HAINT BLUE SUBDIVISION

APPLICATION NUMBER 10 DATE December 1, 2016

REQUEST Subdivision

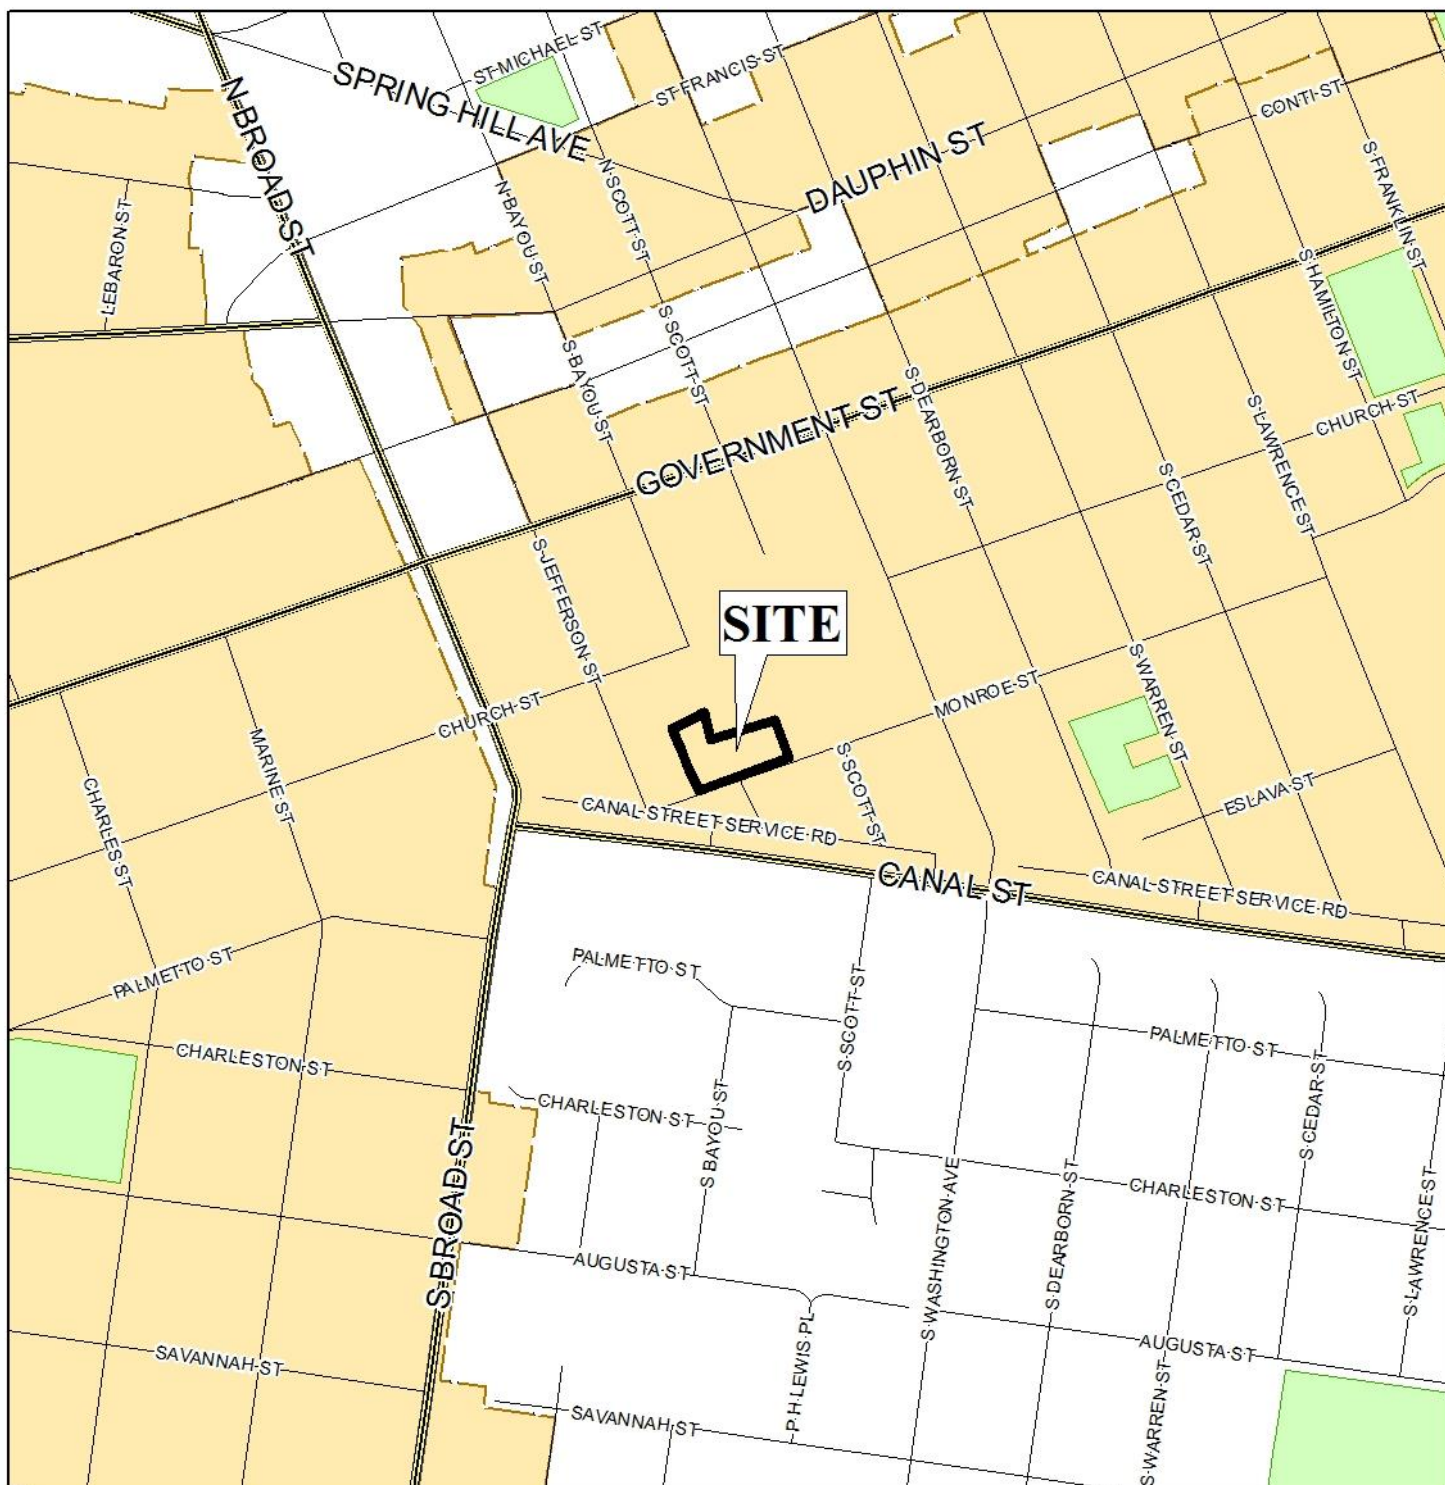
As proposed, Lot 1 will be approximately 128 feet wide, while Lot 2 will be approximately 130 feet wide at the street frontage. Per the DDD requirements, lots may be between 14 and 180 feet wide in T-5.1 Sub-districts. The lots will range in size from 12,650 square feet to 19,515 square feet.

Building setbacks within a T-5.1 Sub-district, according to Section 64-3.I.8.(d) of the Zoning Ordinance, are as follows: front, from 0 to 5 feet; side and rear, 0 feet. The preliminary plat includes a note listing all applicable building setbacks. The existing building on Lot 1 is setback approximately 11.4 feet, while the existing building on Lot 2 appears to be setback 0.1 feet at its minimum distance. The 25-foot minimum building setback line, required in Section V.D.9. of the Subdivision Regulations, should be waived in lieu of the setback requirements T-5.1 Subdistricts of the Downtown Development District, found within the Zoning Ordinance.

There is a 20-foot parking setback requirement for the T-5.1 Sub-district. This is noted on the preliminary plat, however, it should be pointed out that it appears that there may be existing parking within this required setback, thus modifications to both Lots 1 and 2 will be required to ensure that all parking is at least 20-feet from the front property line. All parking areas must be appropriately screened per the requirements of Section 64-3.I.11.(b)(3) of the Zoning Ordinance.

Section 64-3.I.11.(c)(3) of the Zoning Ordinance limits driveway widths to 25 feet within the frontage. Lot 1 has an existing driveway width of approximately 114 feet, while Lot 2 has an existing driveway width of approximately 48 feet. Each driveway should be reduced in width to

25 feet, with the remaining area restored with sidewalks, curb and gutter, per City of Mobile requirements.

Frontage build-outs in T-5.1 Subdistricts shall be a minimum of 80%, per Section 64-3.I.15.(a)(2) of the Zoning Ordinance. Where the build-out is less than 80%, a streetscreen ranging in height from 4 to 8 feet is required. The build-out of proposed Lot 1 appears to be 47%, while the build-out of Lot 2 appears to be 62%, thus streetscreens will be required. Materials for streetscreens are specified in Section 64-3.I.15.(a)(2)III. of the Zoning Ordinance.

- 1) Revision of the plat and placement of a note on the plat to reflect the provision of a streetscreen for each lot, in compliance with Section 64-3.I.15.(a)(2) of the Zoning Ordinance;

- 2) Revision of the plat to depict the 20-foot parking setback line, required by Section 64-3.I.8.(d) of the Zoning Ordinance;
- 3) Placement of a note on the plat stating that parking shall be screened in accordance with Section 64-3.I.11.(b)(3) of the Zoning Ordinance;

- 4) Placement of a note on the plat stating that each lot is limited to one curb-cut, with the size, design and location to be approved by Traffic Engineering and to comply with AASHTO standards;

- 5) Revision of the plat and placement of a note on the plat to reflect a maximum driveway width of 25 feet for each lot, in compliance with Section 64-3.I.11.(c)(3) of the Zoning Ordinance: removed driveway areas to be restored with curb-and-gutter and sidewalks, per City of Mobile requirements;
